Addendum #2

Bid Opportunity: 2022-RFT-002 Water Tower Rehabilitation

DEEP RIVER WATER TOWER REHABILITATION

CONTRACT No. 2022-RFT-002 ¹

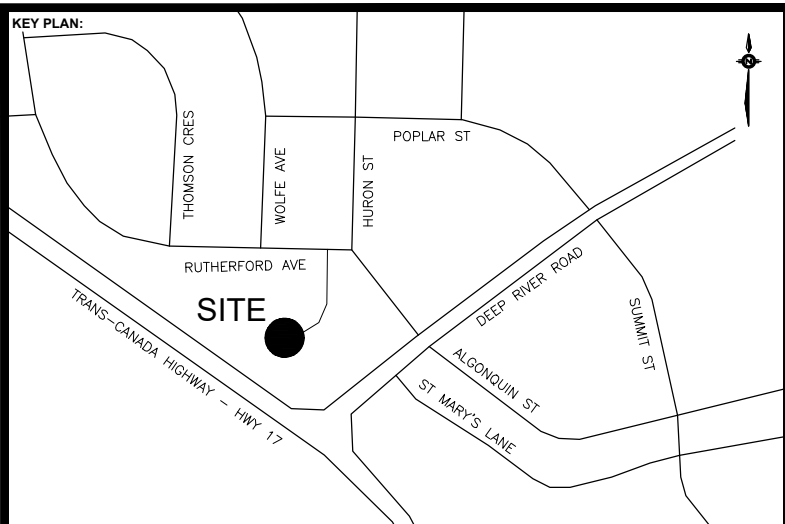
2.2 Question 2: In reference to Section 13600 2.3.6.7 is 22 kN a realistic requirement for the tie-off post?

Answer: The design load shall be 22 kN.

- NOTES:**
- TIE OFF COLUMN TO BE DESIGNED FOR A LOAD OF 22kN APPLIED IN ANY DIRECTION AT ANY HEIGHT.
 - EXACT LOCATION OF TIE OFF COLUMN TO BE AGREED UPON WITH ENGINEER.
 - STRENGTHEN EXISTING ROOF PLATES WITH REINFORCEMENT PLATES AS REQUIRED.
